Item Name: 205 Skidtube bent detail

| DRAWING NO. D2580 | TITLE 205 SKIDTUBE ASSEMBLY | REV. E | DART AEROSPACE LTD ENGINEERING ORDER | D.E.O. NO. D2580-E-1 | SHEET NO. SHEET 1 OF 1 | SCALE NTS |

PURPOSE:

CHANGE ALL C'BORED WELDED CROSSBOLT SPACERS TO SWAGED SPACERS

SECTION B-B, F-F, I-I
NOT TO SCALE

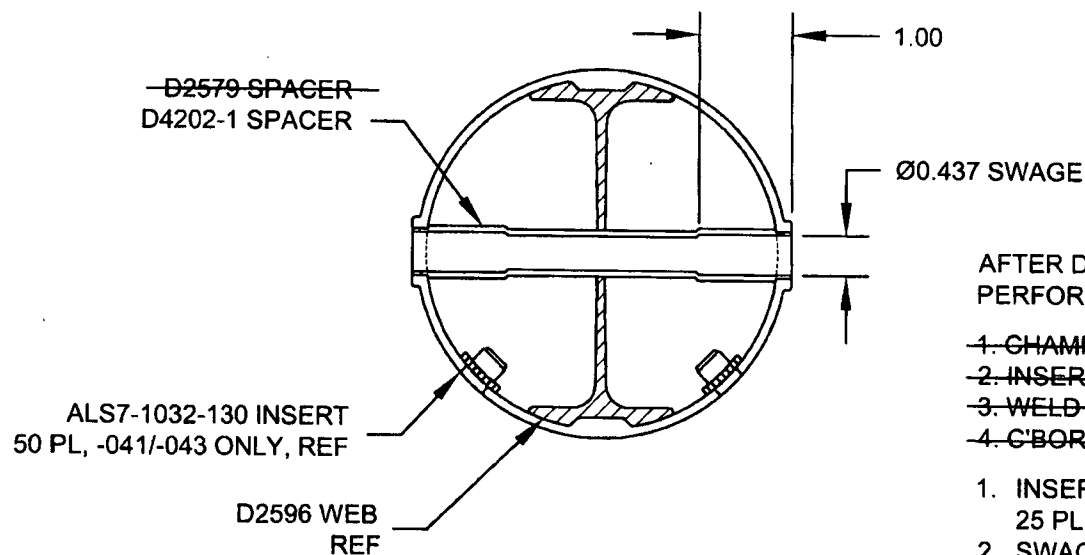
SECTION B-B, SECTION F-F, & SECTION I-I ARE AMENDED AS FOLLOWS
FOR ALL HOLES THAT WERE ORIGINALLY C'BORED:

*** FOR -045 SKIDTUBE ONLY:**

WELD 4X D2579 SPACERS PER DWG
IN LOCATIONS MARKED "NO C'BORE".
REF SHEET 4 OF DWG.

1. CHAMFER HOLE 0.050 X 45°
2. INSERT D2579 SPACER (20 PLACES)
3. WELD INTO PLACE AND GRIND FLUSH
4. C'BORE D2579 SPACER TO Ø0.437 X 1.00 DEEP

1. INSERT D4202-1 SPACER, 20 PL (-041) OR 20 PL (-045) OR 25 PL (-047)
2. SWAGE TO Ø0.437 X 1.00 DEEP PER QSI 002
3. TRIM / GRIND FLUSH PER QSI 002
